REPORT TO THE CALGARY PLANNING COMMISSION

DEVELOPMENT PERMIT	ITEM NO: 15
	CPC DATE: 2005 March 24
	DP NO: DP2004-3284

PROPOSAL:
Apartment Building (181 Units)

PARKING LEVEL P3

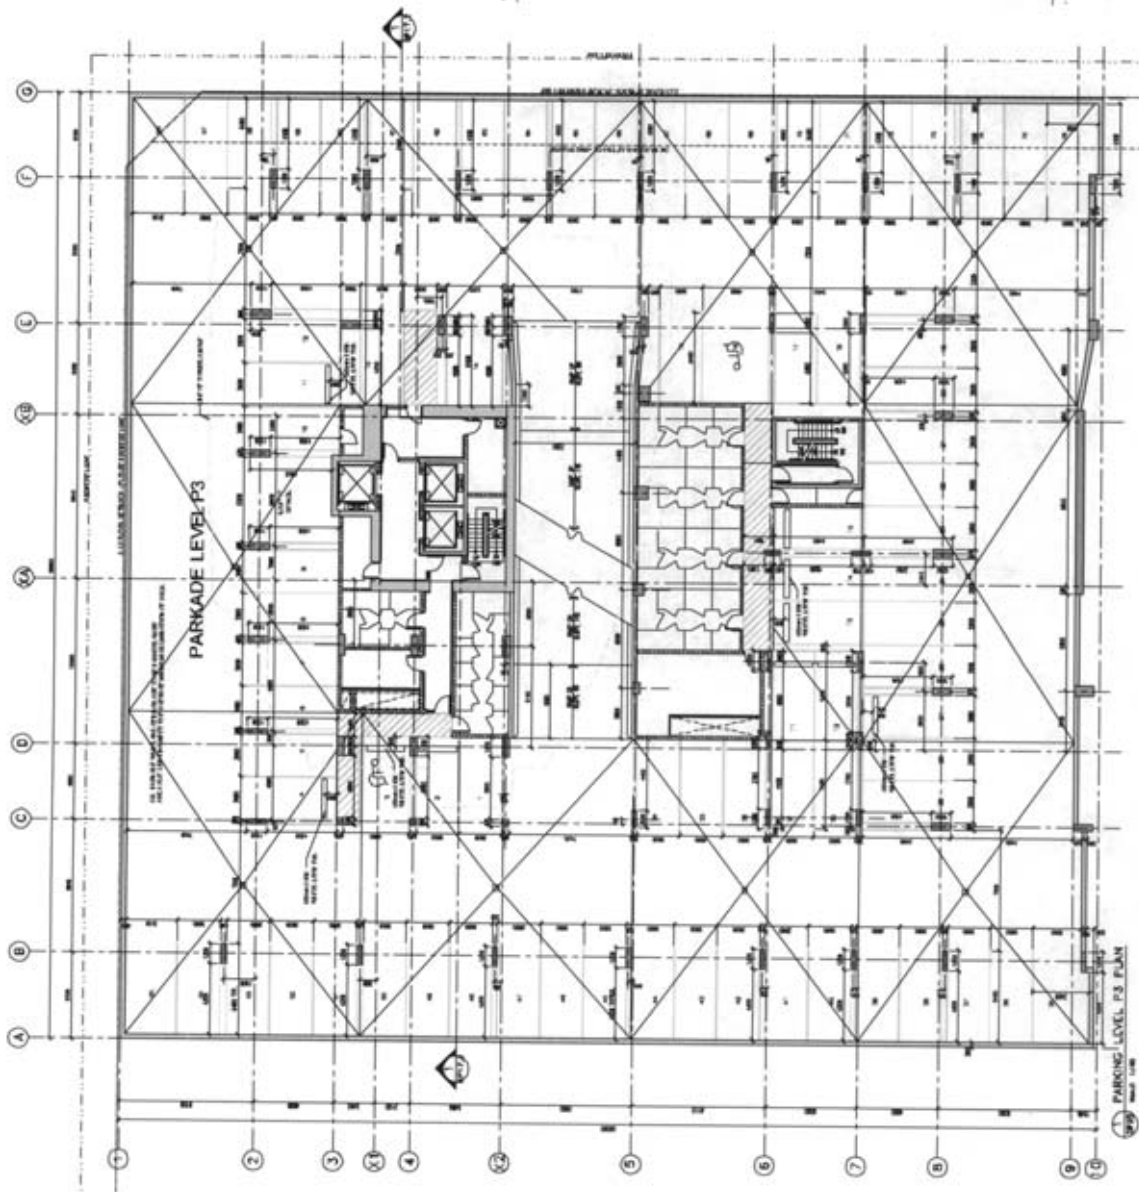
- Indicate wheel stop height for the surface parking lot.
 - Parking stalls 17 P4 and 20 P3 require wheel stops.
15. The applicant shall remove the painted walkways from the handicapped parking stall envelopes on parkade levels P1 – P4.

- Stall #7 #19 P4, Stall #10 #22 P3, Stall #10 P2 and Stall #10 P1.
 17. One access only shall be permitted to the north side of 12 Avenue from 3 Street to Olympic way SE. The applicant shall indicate that the parkade entrance for the sandstone and bungalow will be accessed internally. (See permanent conditions.)
